ADDENDUM NO. 02

**High School Addition & Renovation
Jr. High Addition & Renovation
Intermediate School Controls Renovations
Primary School Controls Renovations
Softball Concessions
Ellettsville, IN 47429**

ADDENDUM NO. TWO

**Richland-Bean Blossom CSC
Additions and Renovations**

LOW ROOF FRAMING PLAN - UNIT E

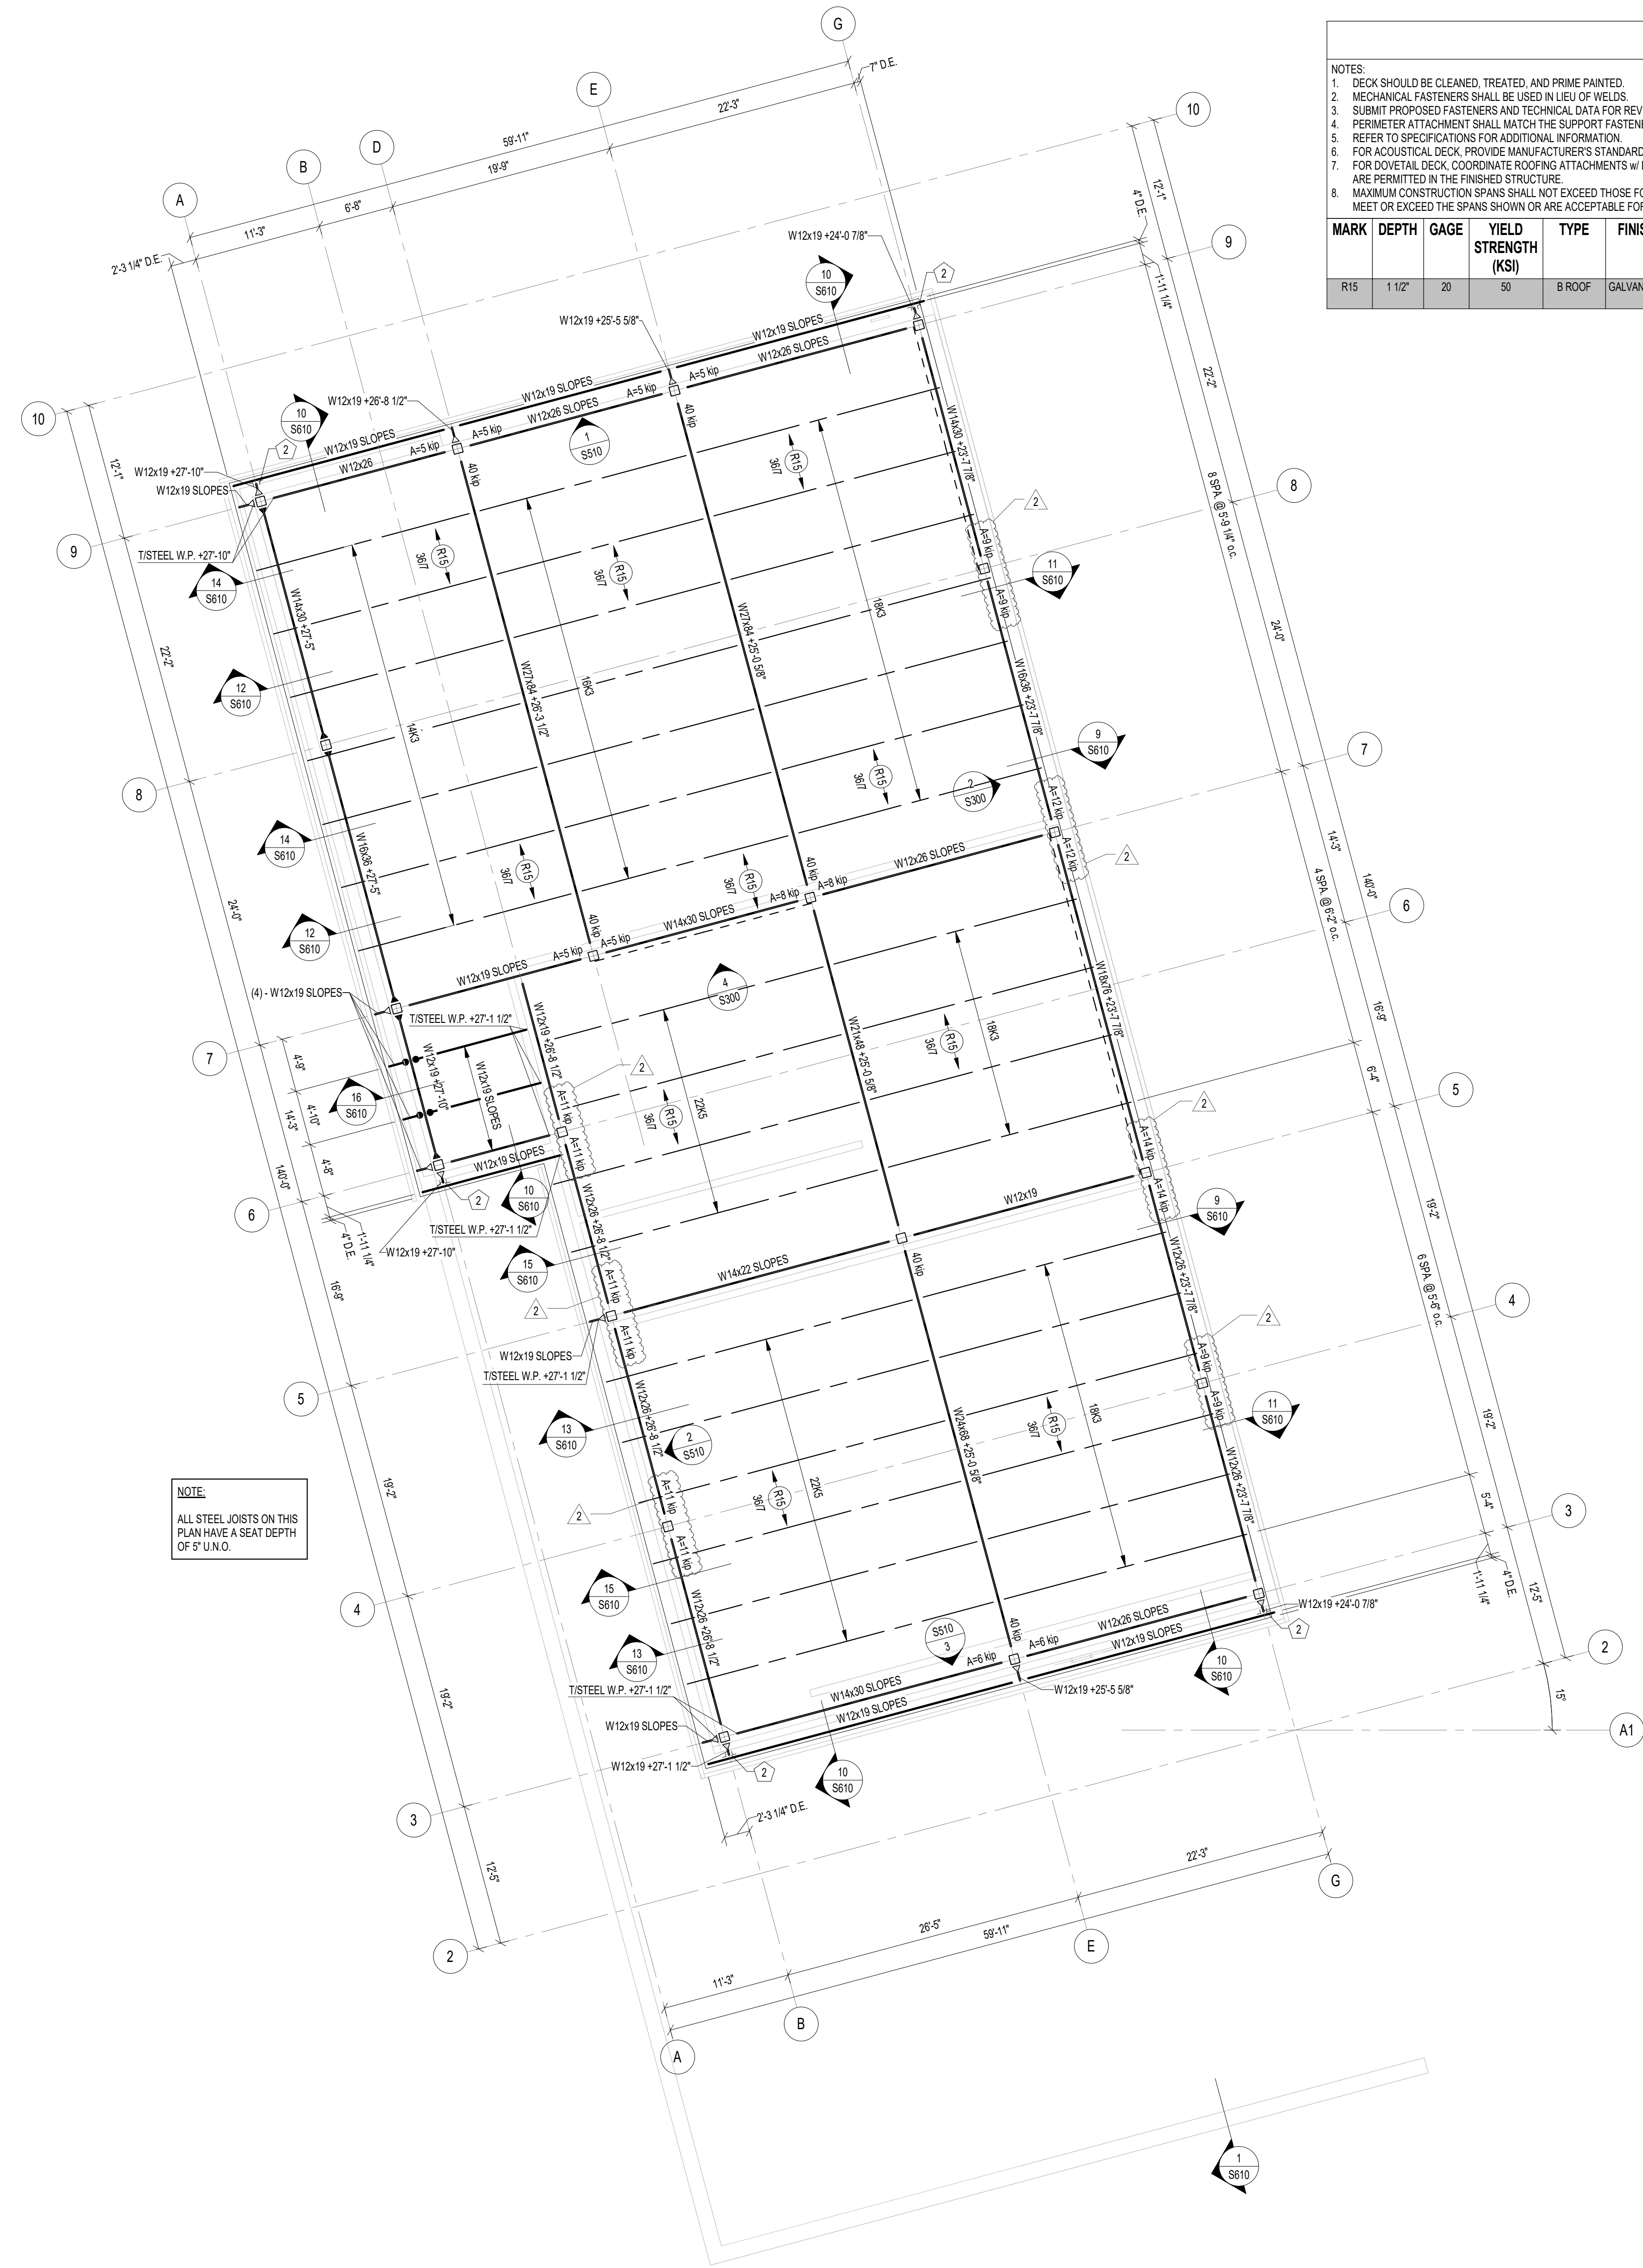
- a. Added new keynotes callouts on plan and their description in schedule.
- b. Replaced framing section callouts with new sections.
- c. Updated axial reactions of framing members due to increase in parapet height of some walls on the low roof level.

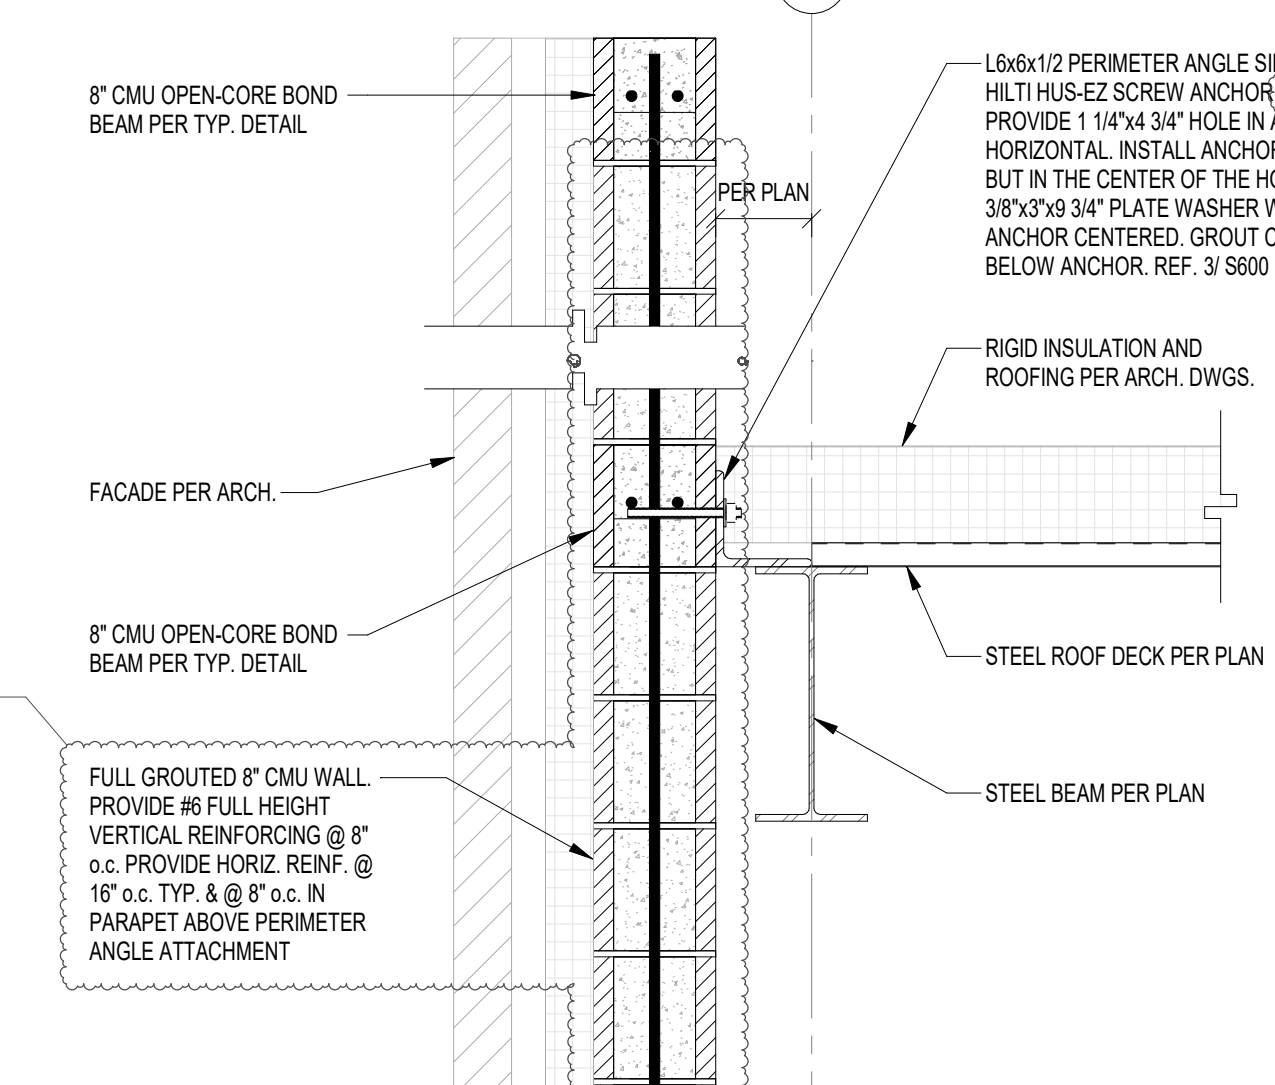
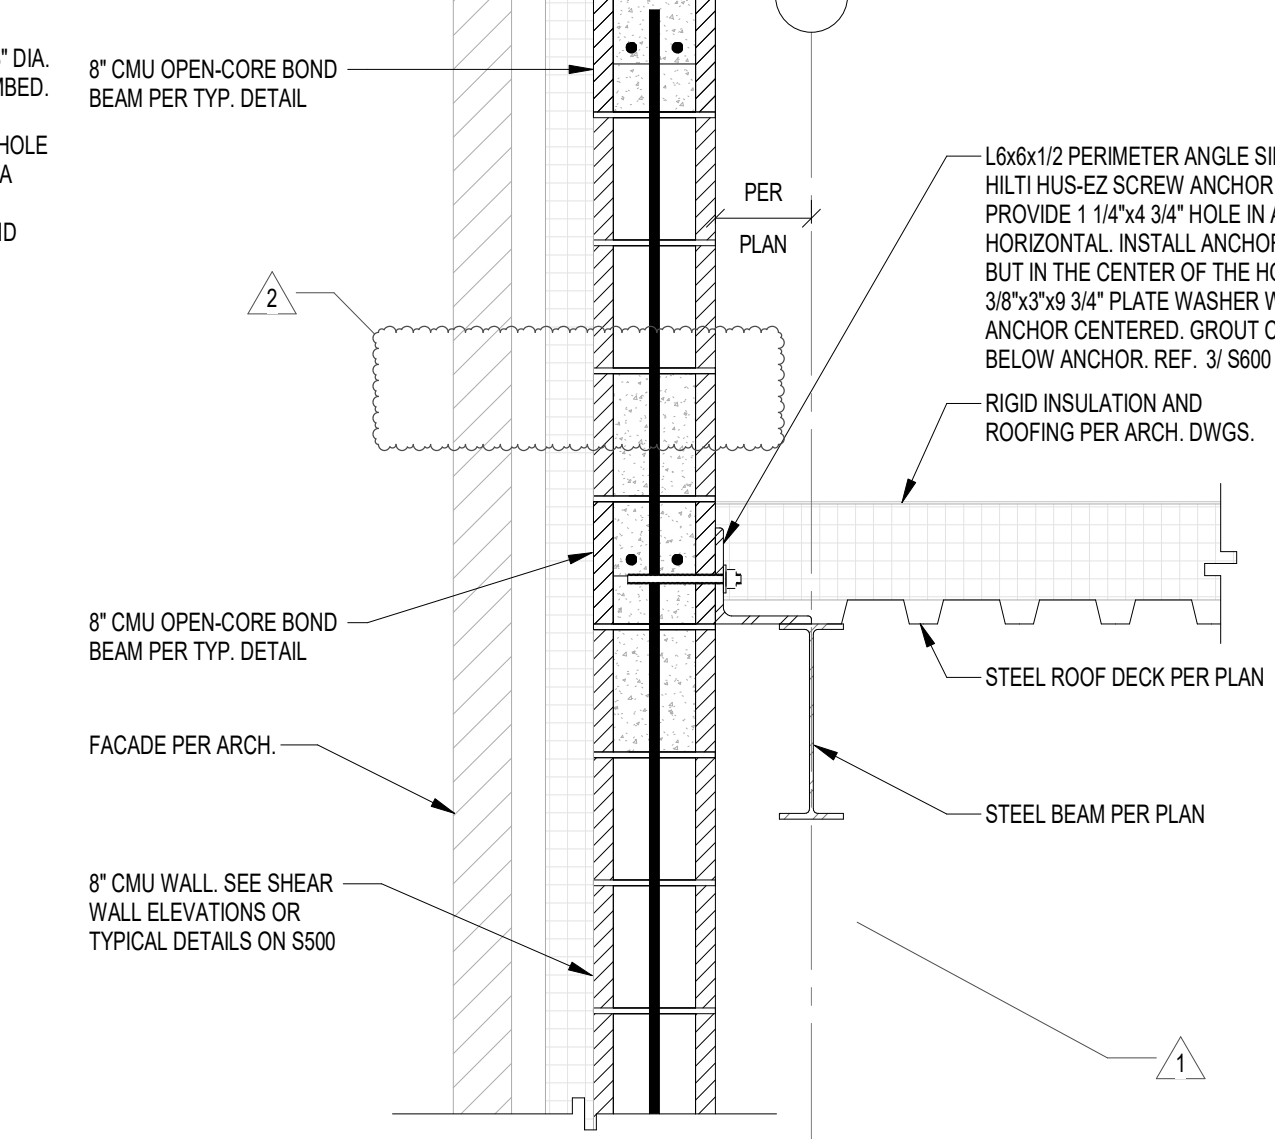
- a. Updated CMU wall and reinforcing callout and added detailing to show full height grout on 1/S610. Updated wall to perimeter angle connection.
- b. Removed separation on 2/S610 to show entire parapet wall.

1 FRAMING SECTION
S611 SCALE: 1" = 1'-0"

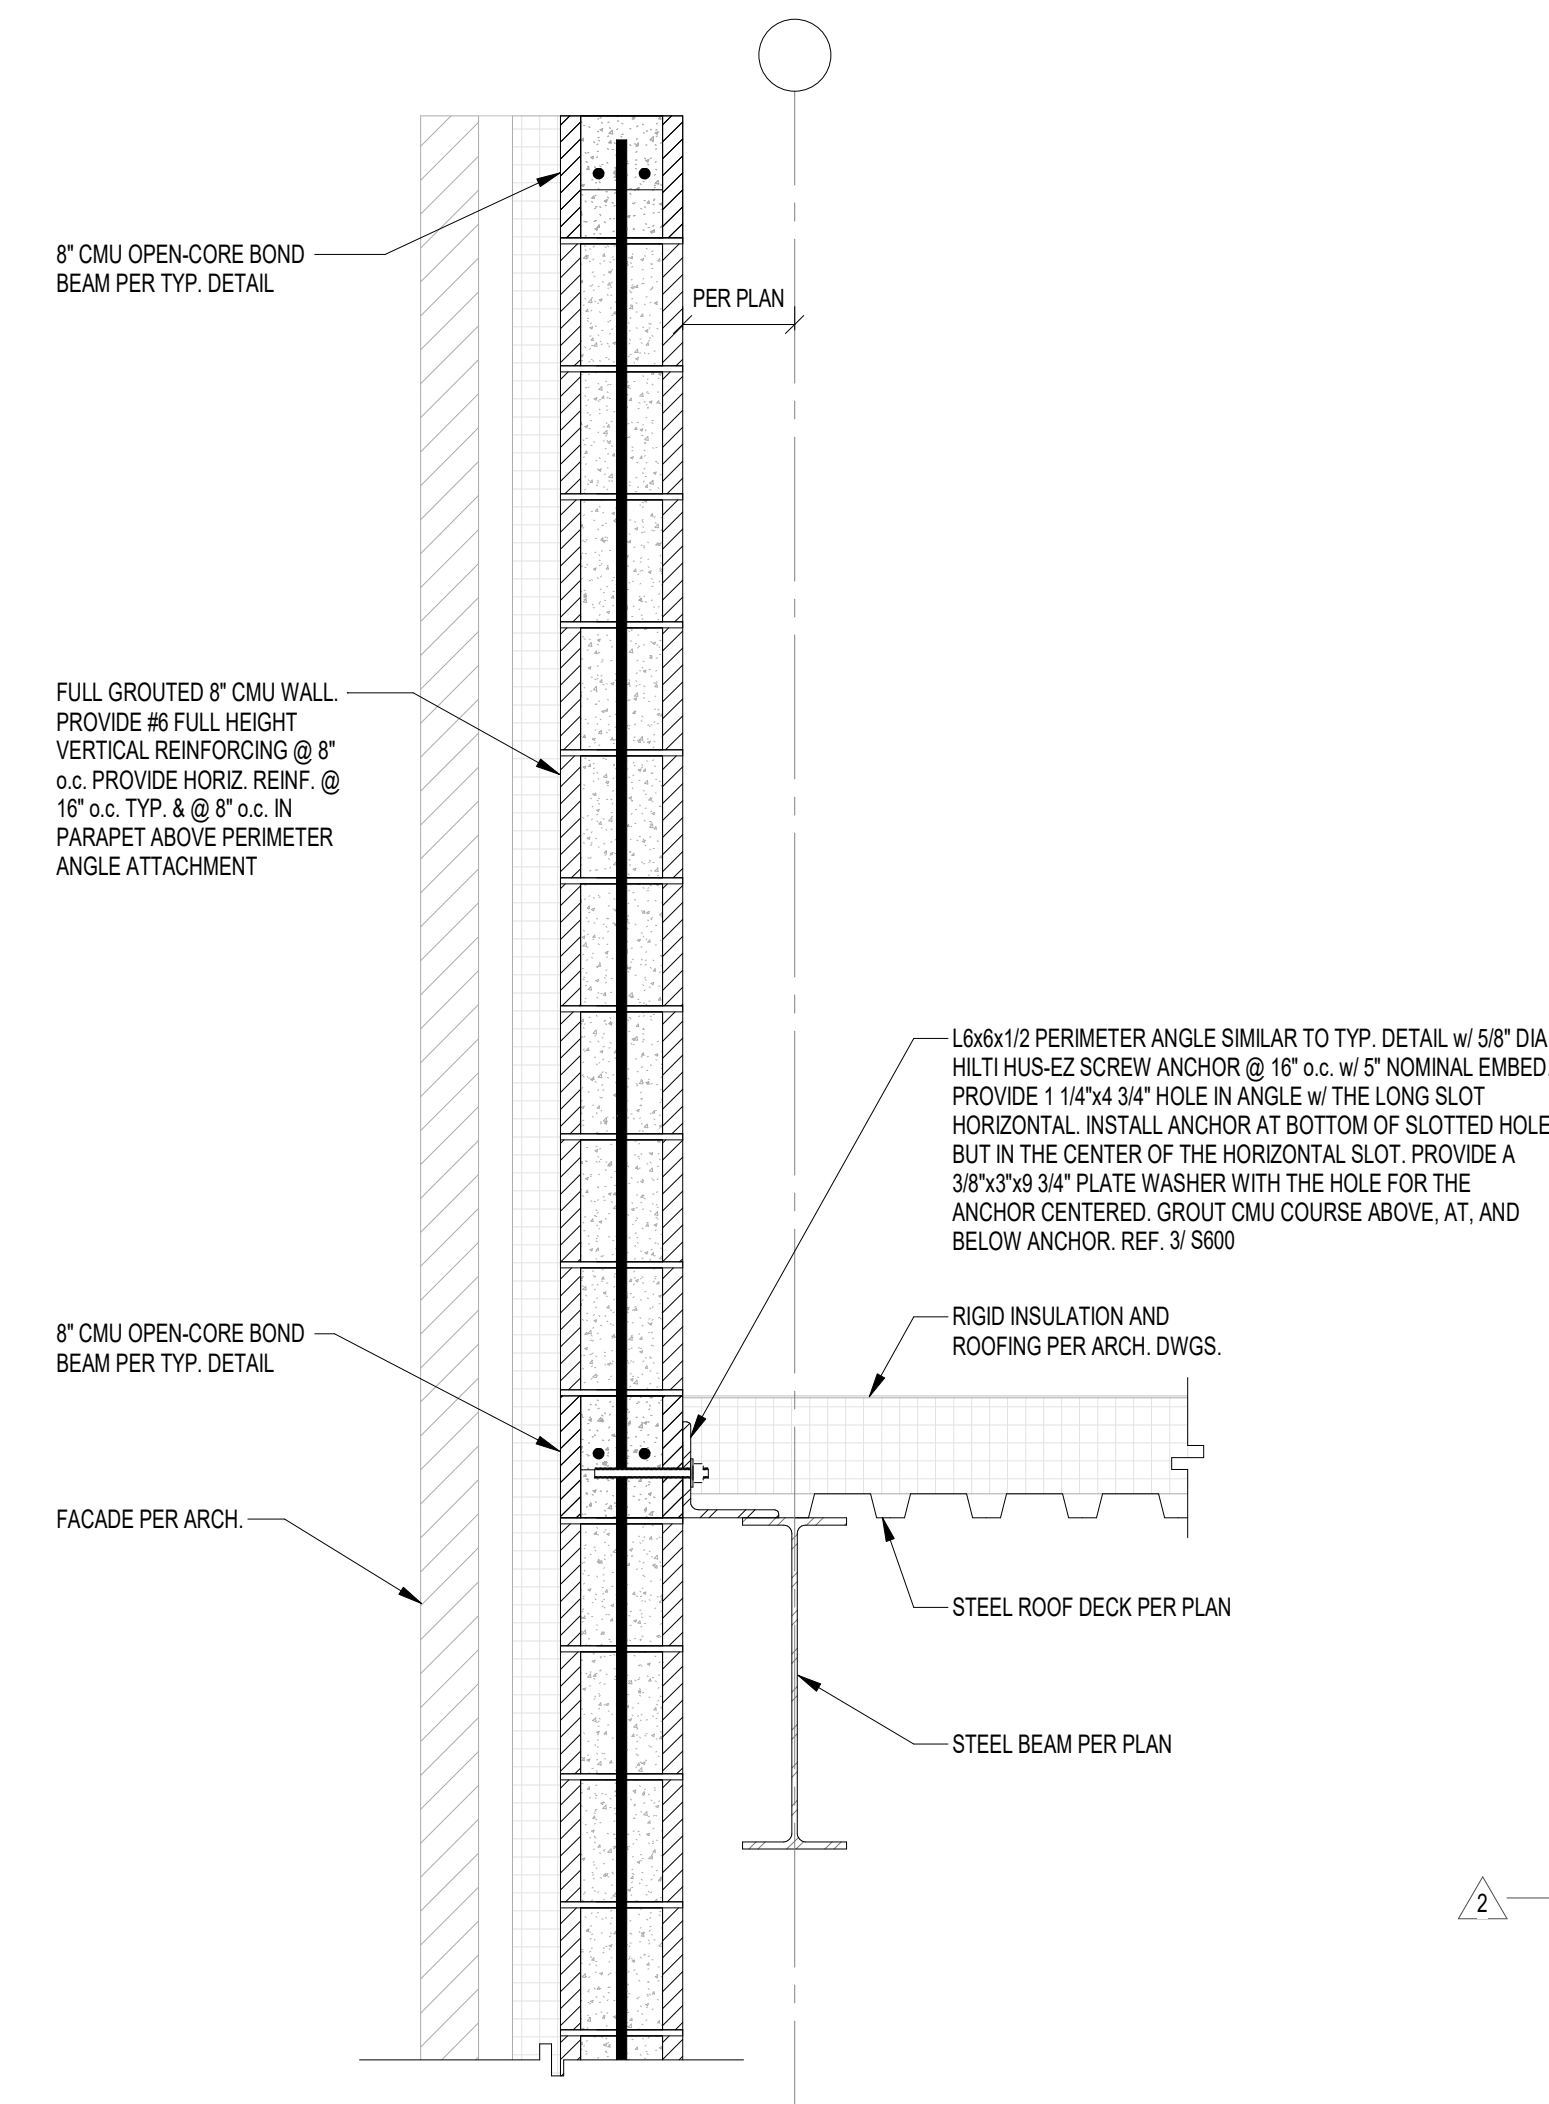
- a. Added new sheet to include new framing section.
